**AUTHORIZATION TO DISCHARGE UNDER THE NATIONAL POLLUTANT
DISCHARGE ELIMINATION SYSTEM (NPDES)**

Granite Shore Power Schiller LLC

**Schiller Station
400 Gosling Road
Portsmouth, NH 03801**

Figure 2-1: Example illustrating the decline in abundance of Winter Flounder life stages from spawning to adulthood based on published life history parameters³.

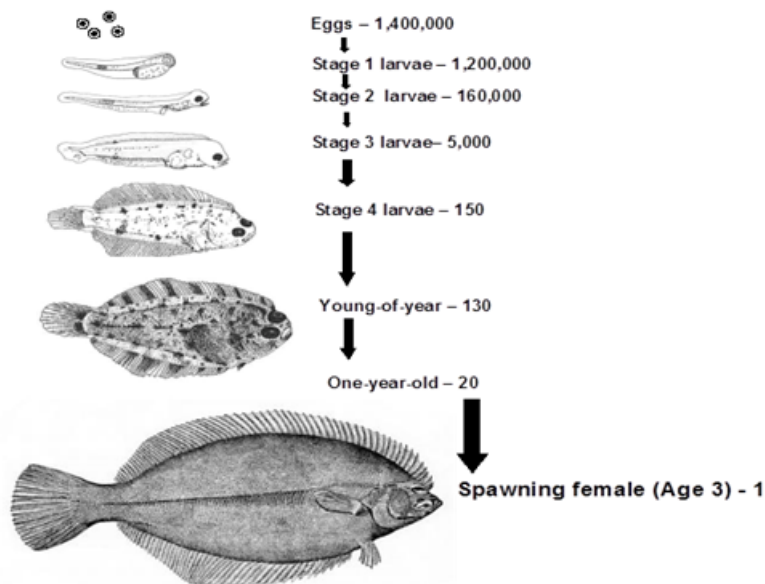
Figure 2-1 in the 2016 Enercon-Normandeau Comments depicts the survivorship curve of the Winter Flounder and puts the above-referenced comments in proper context by demonstrating that a miniscule number of eggs and larvae of organisms subject to entrainment at Schiller Station would survive to adulthood even in the absence of the facility’s CWISs:

Only one out of 1.4 million Winter Flounder eggs is likely to survive in waters similar to the Piscataqua River to become a three-year-old spawning fish—one.¹¹⁸ Moreover, nearly 99 percent of the eggs die of natural causes within 60 days following spawning. Remarkably, fecundities of other abundant fish and macrocrustacean taxa typically entrained by CWISs at Schiller Station are roughly equivalent to the Winter Flounder and/or are comparatively higher than the median taxa. Furthermore, like the Winter Flounder, early life stages of these other abundant fish and macrocrustacean taxa typically entrained by the facility's CWISs also experience high levels of natural mortality.¹¹⁹ Enercon and Normandeau aptly provide that it is because of the “exponential decrease in numbers of fish due to natural mortality” that EPA and the scientific community provide “estimates of the life stages of both fish and macrocrustaceans entrained...as both absolute numbers and their equivalent adults” because “counts of total numbers entrained reveal nothing meaningful about the potential adverse impact of...CWISs on the relevant adult populations.”¹²⁰ “The correct and biologically equitable way for [Region 1] to compare the benefits of different technologies or operational measures that act selectively on the different life stages of fish and macrocrustaceans entrained at [Schiller] Station (such as screening technologies) is by making these comparisons using the equivalent adult values provided in a revised fact sheet.”¹²¹

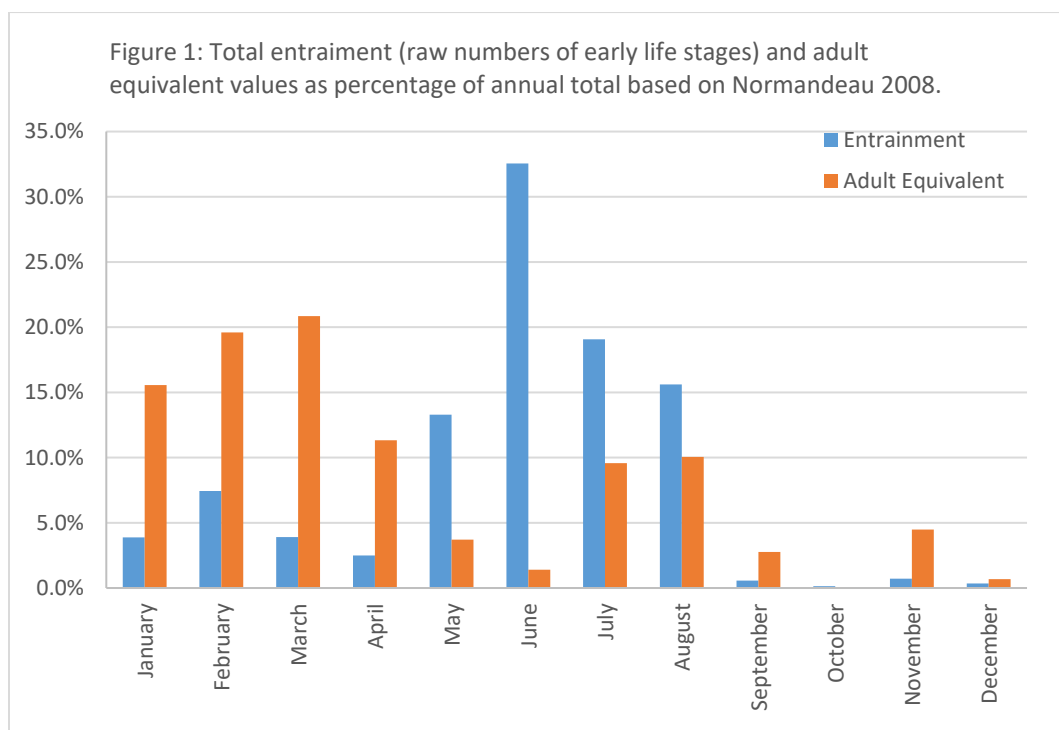
Synapse's analysis assumes that cooling towers and wedgewire screens act equally to reduce entrainment of the early life stages of all fish and macrocrustaceans, but this is not likely to be the case. Cooling towers, which reduce entrainment by reducing water withdrawals, are equally effective for all life stages and all species – in other words, flow reductions are not biased towards any particular life stage or species. On the other hand, the effectiveness of wedgewire screens depend on the life stage and species entrained. In the Fact Sheet, the effectiveness of screens was assumed to be based first on the ability of the screens to exclude organisms based on mesh size (which favors larger eggs and larvae with greater body depth), and then on the ability of the organisms to survive contact with the screens (which favors eggs and all life stages of macrocrustaceans). More recent research on wedgewire screens suggests that larval avoidance may also play a role in reducing entrainment, which, if accurate, would selectively act on larger, post-yolk sac larvae that have attained some capacity to swim and avoid entrainment. These individuals are also often the most likely to survive to the next life stage and therefore, contribute proportionally more to adult equivalent metrics.

The influence that the stage- and species-specific survival rates has on the estimate of adult equivalents is evident in the adult equivalent abundance results in the 2008 Biological Report (AR-136). Figure 1 illustrates that monthly adult equivalent abundance was highest during the winter months of January through March 2007, but these months accounted for only around 4% to 7% of entrainment. Entrainment (as raw numbers of eggs and larvae) was highest during the summer months of June through August. June, the month with the highest entrainment (32.5%), was among the lowest months for adult equivalent fish (1.4%) because eggs are the dominant life stage entrained in June and eggs, due to the high natural mortality of this life stage, contribute less to the adult equivalent metric than older life stages.

Figure 2. Log number of eggs entrained per 100 m³ during ichthyoplankton sampling in the Piscataqua River (2001, 2002, and 2003) and at the Schiller Station CWIS (2007).

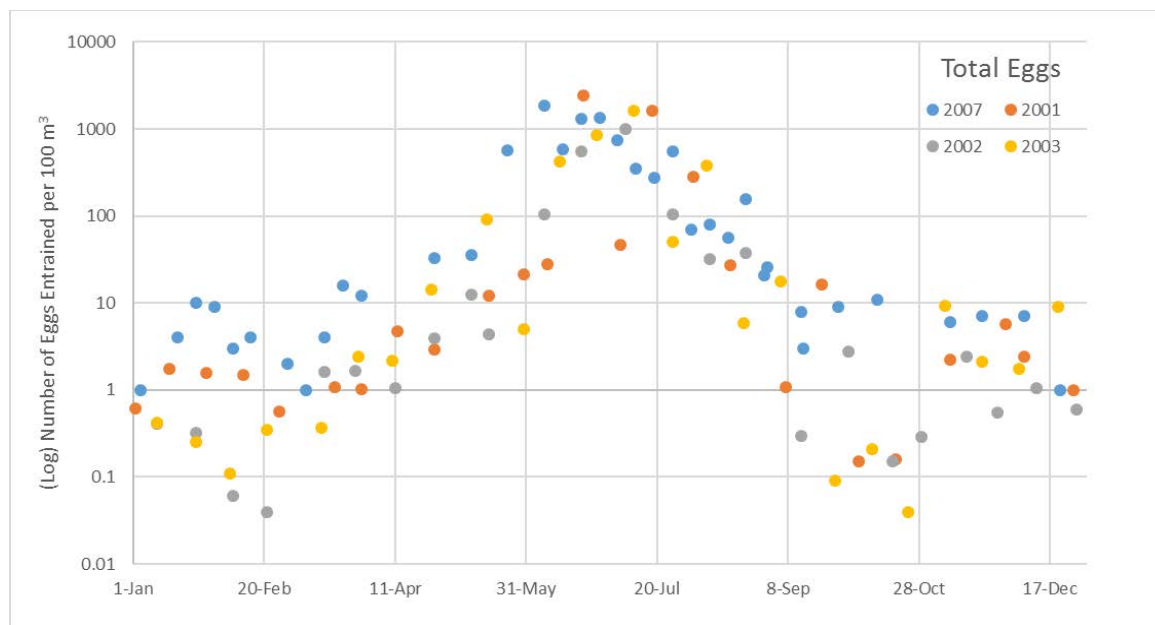
The figures illustrate that the number of eggs and larvae collected during Normandeau's 2006-2007 study is generally consistent with the mean values for eggs and larvae in the Piscataqua River during 2001 through 2003 on both a seasonal and annual basis. Entrainment densities also appear consistent with mean in-river densities during the months of May and September, even though the 2006-2007 biological study sampled once every two weeks during May and September, rather than weekly. Based on this comparison to three years of in-river ichthyoplankton data, there is no evidence that Normandeau consistently underestimates entrainment or that the 2007 data should be considered a "lower bound" estimate for entrainment of eggs and larvae at Schiller Station.

Figure 4. Net generation (tons of fuel) from 2006 through 2016 based on plant-level data from the U.S. Energy Information Administration.

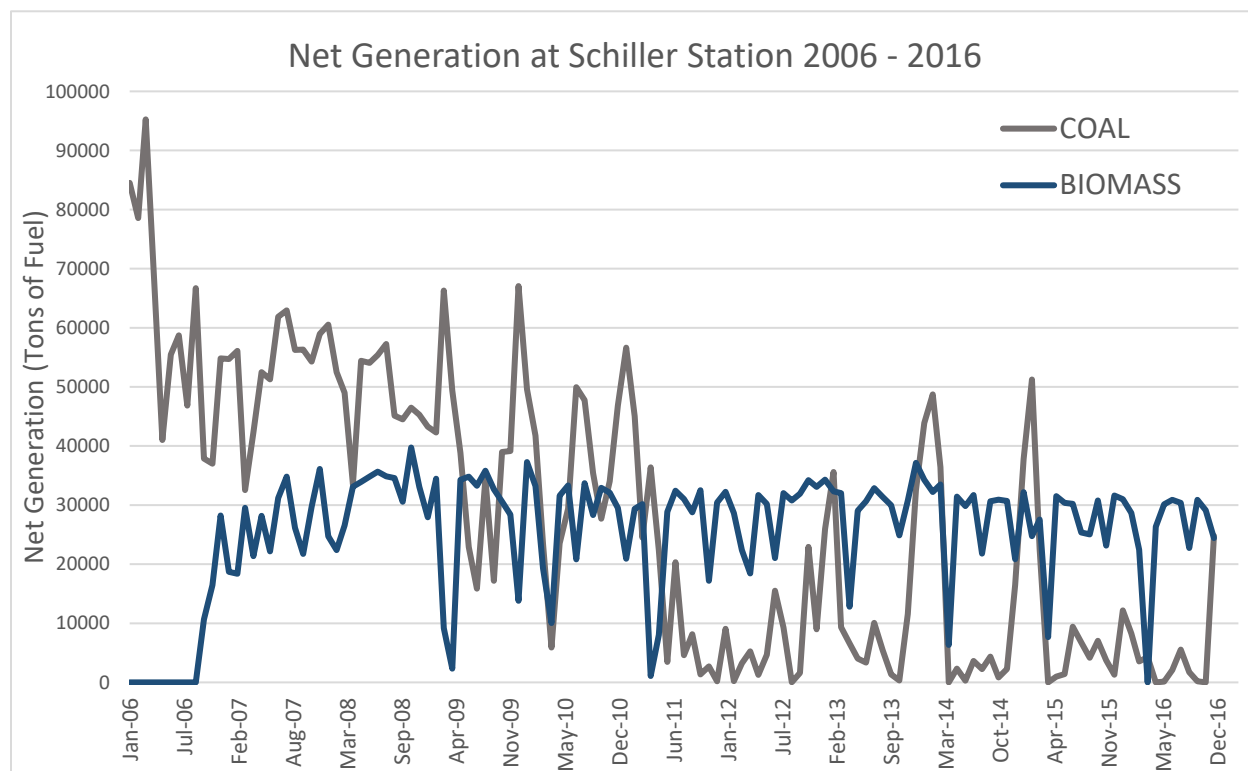
As Sierra Club states, the operation of Schiller Station has changed dramatically since 2008, when the engineering response and biological report were completed. At that time, the facility was still operating as a baseload facility and the average daily withdrawals between 2002 and 2007 were about 7.3% less than design flow. *See* Fact Sheet at 93. At the time that the Draft Permit was issued, Schiller Station Units 4 and 6 were no longer operating as baseload, but rather to meet electricity needs during peak load times, generally during the winter and, less commonly, in the summer months. *See* Fact Sheet at 149. Figure 4, below, illustrates the shift from coal to biomass as the primary fuel source for Unit 5 beginning in mid-2011 and the declining net generation at coal-burning Units 4 and 6 in the last 5 years or so. *See* AR-402. Based on discharge monitoring data from 2012 through 2016, Schiller Station is operating at average intake flows equal to 67.8 MGD, which is about 46% less than design flow (in comparison to the 7.3% difference based on flows from 2002 to 2007). This decline is largely due to decreases in the intake flows at Units 4 and 6, which are operating at an average of about 35% and 30% of DIF, respectively.

EPA did not factor this change in operation into its assessment of the adverse environmental impacts from entrainment. The estimated numbers of eggs and larvae entrained, and of adults and juvenile fish impinged, were based on the capacity at design intake flow (at maximum

Figure 8-1: Ichthyoplankton entrainment losses (all taxa and life stages combined)

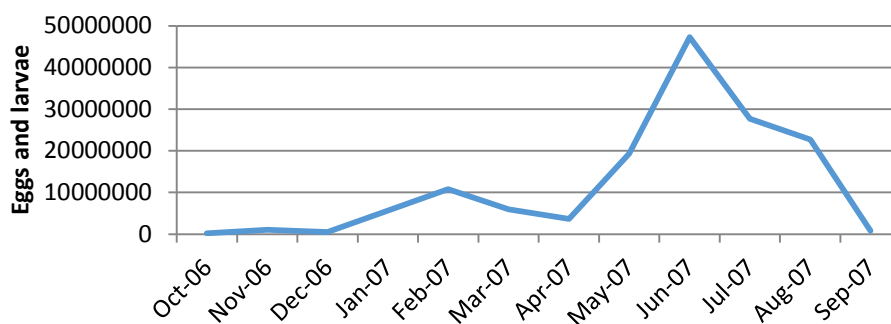
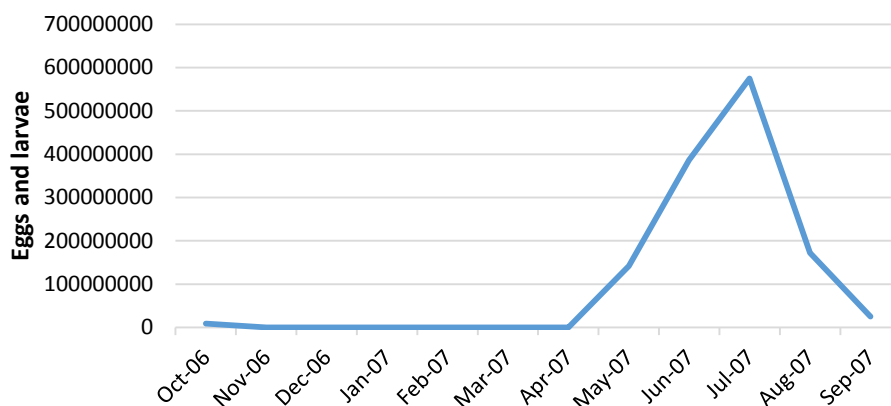
- Page 61, American Lobster: See Comment a. above regarding one parenthetical citation in this paragraph.
- Page 93: *“Entrainment losses of ichthyoplankton peaked in July, with a much smaller peak in the winter (January-March) (Figure 8-1).”*

- Figure 8-1 shows peaking of ichthyoplankton in June, not July. Update throughout to reflect peaking in June.
- Page 170: *“The Draft Permit includes the following compliance schedule at Part I.A.14.b:”*
